Determination 2018/038

Regarding the refusal to issue a code compliance certificate for a 10-year-old house with mixed claddings at 27 Terrace Avenue, Mount Maunganui, Tauranga

Figure 1: Approximate site plan

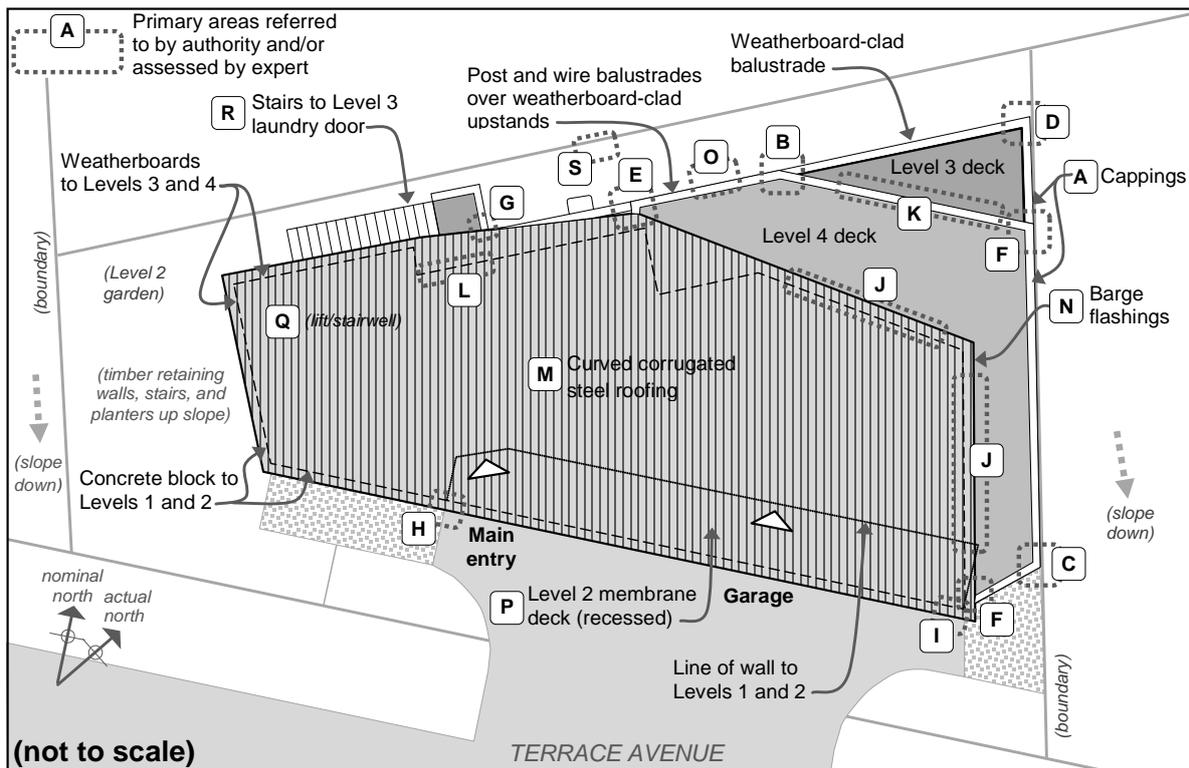
1. Lack of kick out to balustrade cappings (Area A)
2. Deck outlets and overflow provisions (Area B, C and D)
3. Lack of rainwater heads (Areas B, C and D)
4. Balustrade/wall junctions (Areas B, E, F, G, H and I)
5. Head flashing/weatherboard junctions (Areas J, K, L)
6. Roofing durability (Area M)
7. Overflow to rainwater head (Area E)

8. Minor cracking to concrete block plaster (Area O)
9. Change to Level 2 deck (Area P)
10. Producer statements for deck membranes.

1. Cap flashings to balustrades does not have the required kick out/birds beak.
2. Deck outlets are not sized in accordance with E2/AS1 and there is insufficient secondary overflow.
3. Saddle flashing construction to deck balustrades requires further investigation.
4. [Fibre cement] weather board is hard on head flashings, minimum 6mm required to prevent capillary action.
5. Roof cladding requires assessment to ascertain durability performance.

- balustrades capped with sloping heavy stainless steel flashings with fully welded joints and 70mm turndown with no kickout or birds beak
- exposed outer face is horizontal bevel back weatherboard, which will slope away from the edge of the capping to provide an anti-capillary gap further up
- the inner face of the balustrade cladding is flat sheet, but is sheltered
- claddings are installed over cavities that can drain any moisture to the outside before it reaches the framing
- the lack of a bird's beak is not considered significant in the circumstances.

- for enclosed decks with parapet balustrades, E2/AS1 calls for:
 - a scupper opening through a balustrade is to be a minimum 200 x 75mm (refer paragraph 8.5.6d of E2/AS1) with the overflow to the to be 1.5 times the area of the discharge downpipe
- the Level 4 membrane deck has a floor area below 30m²:
 - a 90 x 40mm deck outlet discharges through the base of the north balustrade into a rainwater head (Area B)
 - a second 90 x 45mm outlet is located in the southeast corner of the balustrade (Area C)
 - the combination of two outlets and one overflow is considered acceptable.
- the Level 3 membrane deck has floor area below 7m²:
 - a 110 x 50mm deck outlet discharges through the base of the northeast corner balustrade (Area D), with this size considered adequate for the small deck

- paragraph 8.5.6 of E2/AS1 calls for water to discharge via a scupper into a rainwater head
- the deck outlets are connected directly to downpipes which risks water backing up onto the decks if downpipes are blocked
- however, the bottoms of downpipes are open, which prevents water backing up from blocked discharge.

- junctions are formed by extending the top and sides of cappings to lap over the cladding and sealing them at the junctions
- junctions generally appear to be reasonably well sealed and are expected to remain durable for the required 15 years
- however at the west junction of the Level 3 balustrade (Area B):
 - there is a crack at the junction, which risks water penetration behind the capping upstand
 - although there is no visible evidence of water penetration to date, the junction needs attention to ensure ongoing durability.

- lack of overflow to Level 3 deck (Area D)
- lack of rainwater heads to Level 3 and Level 4 decks (Areas B, C, D)
- cracked capping junction to Level 3 deck (Area B)
- corroding roof fixings and barge flashings (Areas M,N)
- lack of overflow to rainwater head (Area E)
- insufficient height of handrails to interior stairs (Area Q).

- lack of overflow to Level 3 deck (Area D)
 - lack of rainwater heads to Level 3 and Level 4 decks (Areas B, C, D)
 - cracked capping junction to Level 3 deck balustrade/wall junction (Area B)

- corroding roof fixings and barge flashings (Areas M, N)
 - lack of overflow to rainwater head (Area E).
- 7.5.2 In regard to Clause D1 Access, I consider remedial work is necessary in respect of the height of the handrails to the interior stairs (Area Q).
